FSCF Changes into Final Design

Slides from Arup Final Design Kick-Off Meeting (11/7/17)

April 11, 2018

Changes to EXC scope – Infrastructure – 4850L Ross Shaft Brow & Access Drift Design

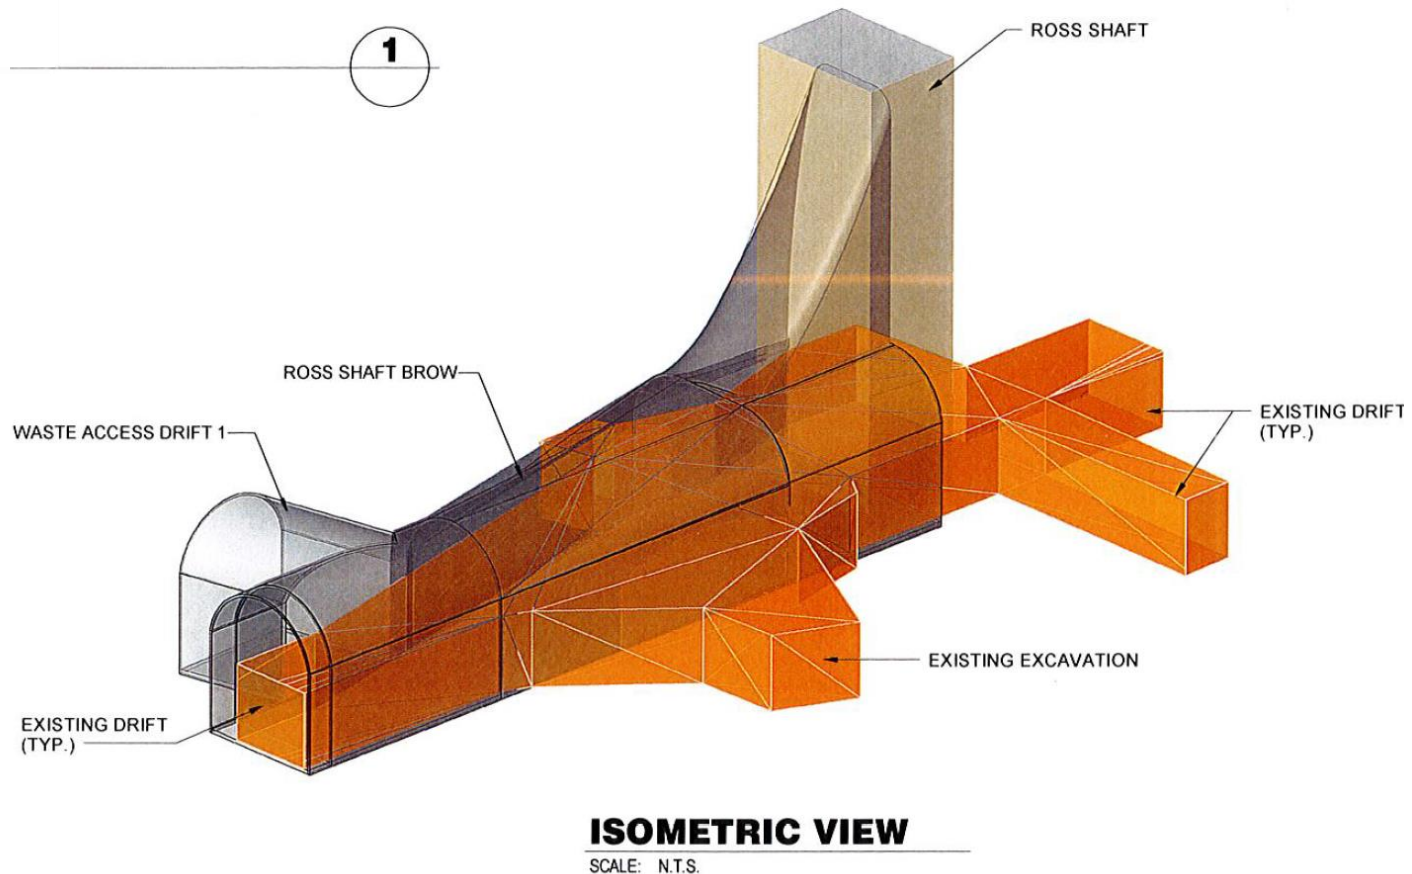
- The Final EXC Design shall include the findings of the Ross Shaft Brow Isolation and Drift Optimization Studies. KAJV to provide input.

Changes to EXC scope – Infrastructure – 4850L Ross Shaft Brow & Access Drift Design

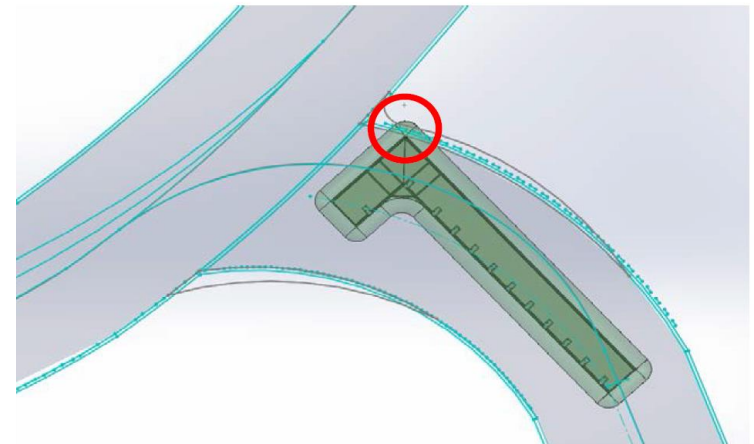
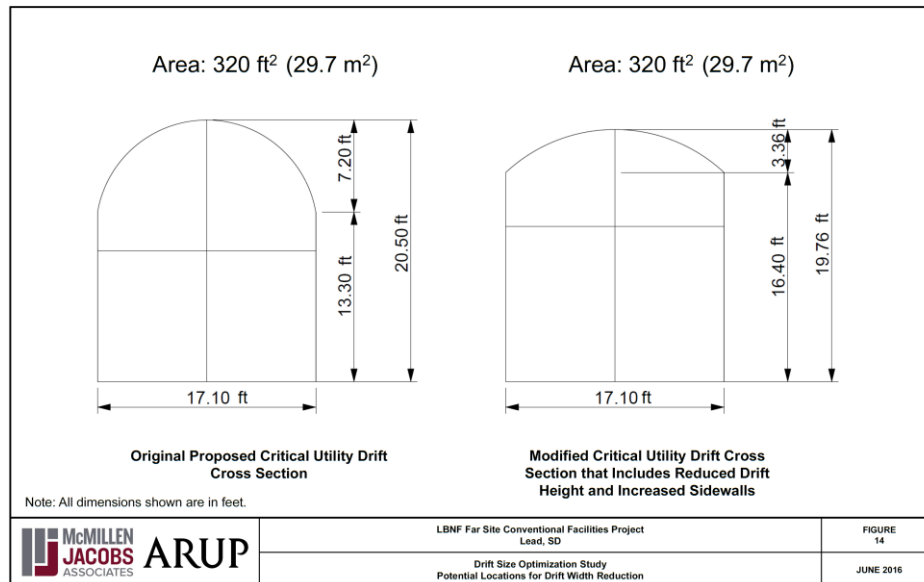
- The Final EXC Design shall include the findings of the Ross Shaft Brow Isolation and Drift Optimization Studies.
- “It is recommended that the critical utility drift cross section shown in Figure 14 be considered going forward to improve drift stability. Further, it is recommended that a five ft. (1.5m) radius is adopted for pillar chamfers and minor modifications needed made to cure radii at intersections to accommodate transportation of beams.” KAJV to provide input.

Changes to EXC scope – Cavern Design – Chamber 3 & 4 Bulkhead & Mid-Cavern Access Drift

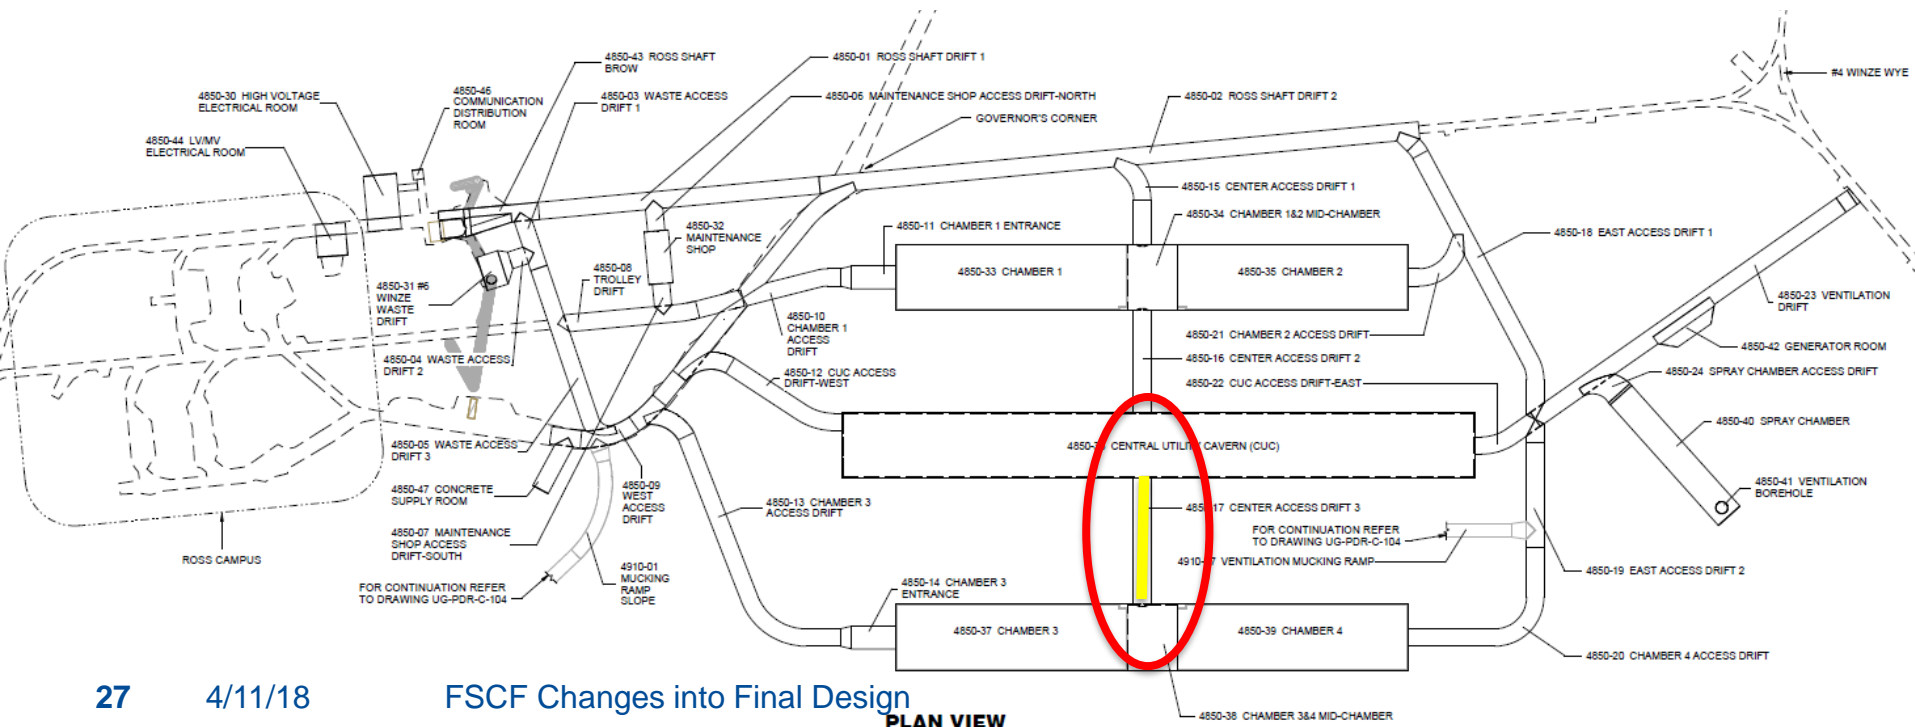
- The Preliminary Design includes a bulkhead between Chambers 3 and 4 to allow construction of a cryostat structure with concurrent excavation of chamber 4. This bulkhead required the access drift to be designed with an offset from the center alignment of the septum pillar.
- The Final Design shall remove this bulkhead design from the scope of work and include a shift of the center line for the mid-cavern access drift to the center of the septum pillar.

Changes to EXC scope – Cavern Design – Chamber 1 & 2 Bulkhead & Mid-Cavern Access Drift

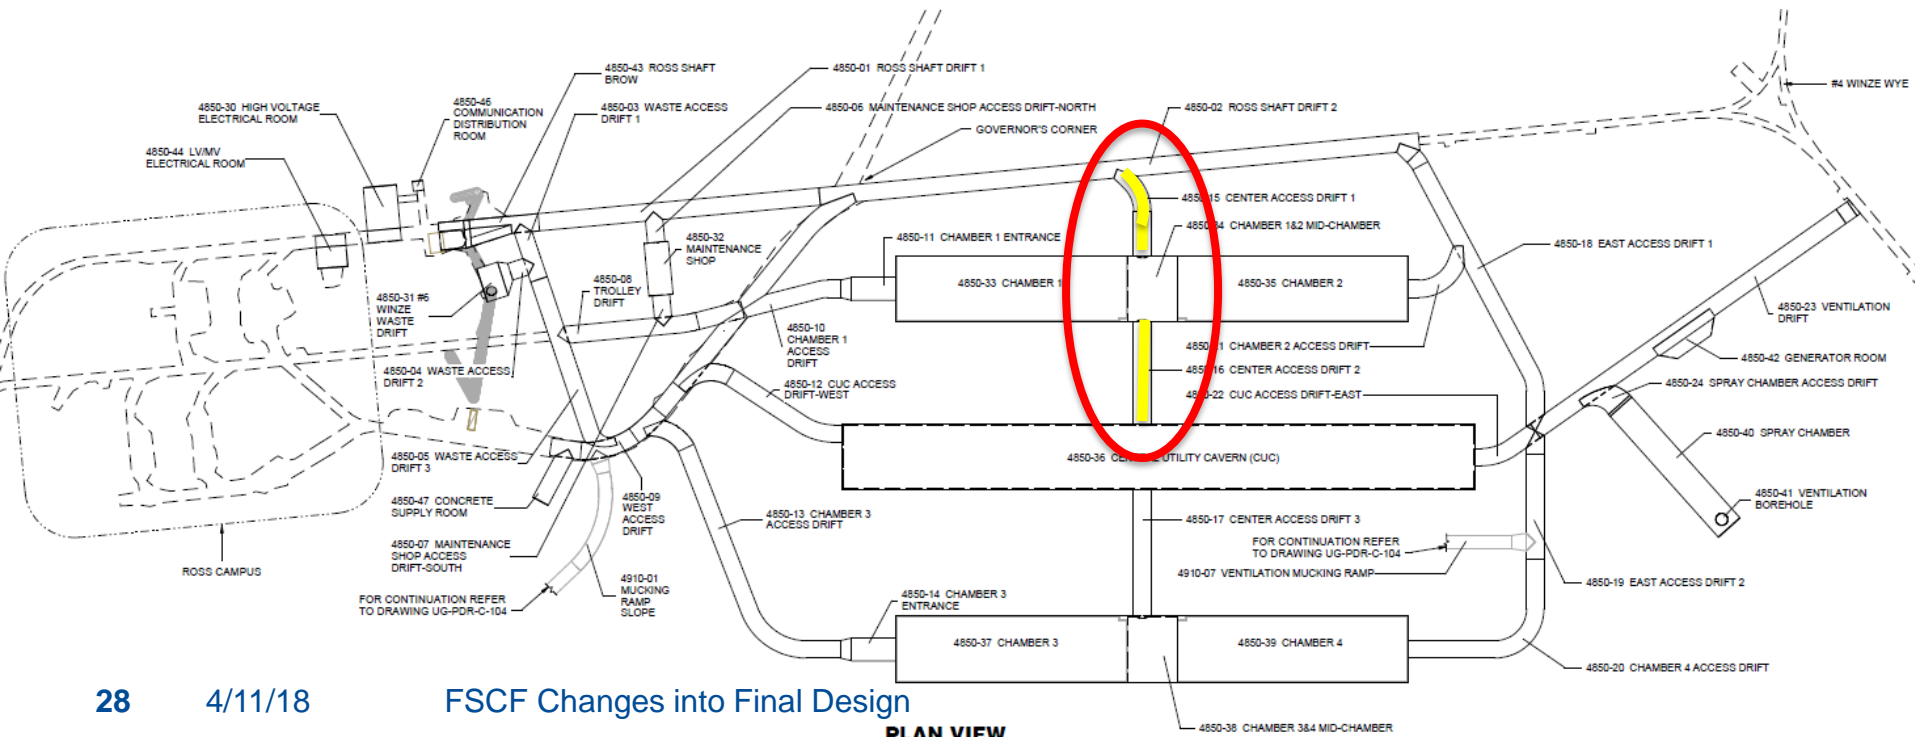
- The Preliminary Design includes a bulkhead between Chambers 1 and 2 to allow construction of a cryostat structure with concurrent excavation of chamber 2. This bulkhead required the access drift to be designed with an offset from the center alignment with the septum pillar.
- The Final Design shall remove the bulkhead design from the scope of work and include a shift of the center line for the mid-cavern access drift to the center of the septum pillar.

DUNE DocDB 464 - Control Drawing F10043159

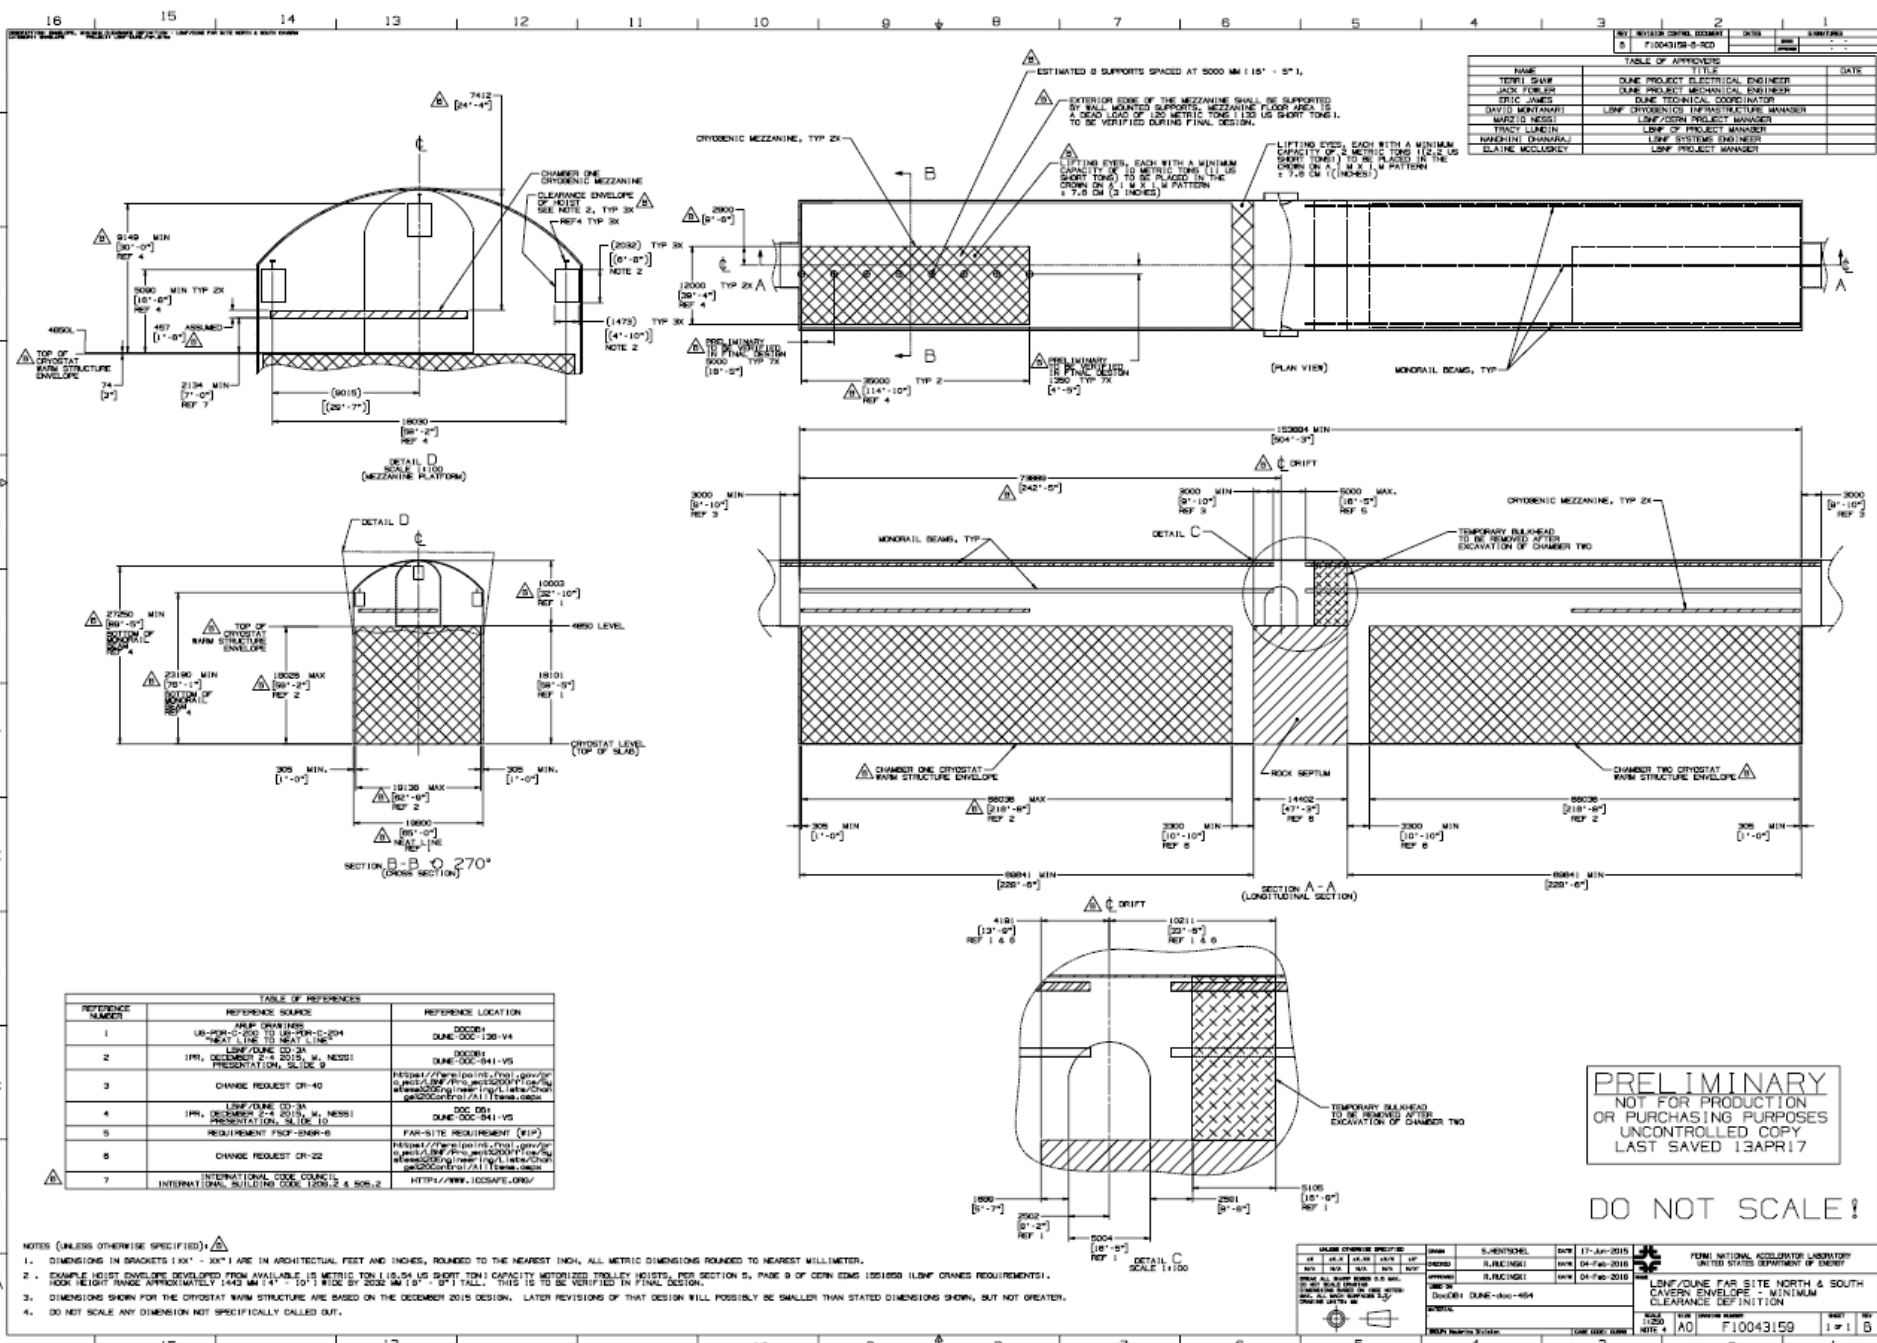
- The Final EXC Design shall include a reduction in septum pillar width to 14.4m, increasing each chamber's overall length by 0.3m. The overall Cavern length does not change.
- The Final EXC Design shall include addition of full-width 3m deep “antechambers” to both ends of the detector caverns, extend monorails into that space, and move the AHU's accordingly.
- See DUNE DocDB 464 - Control Drawing F10043159 (next slide)
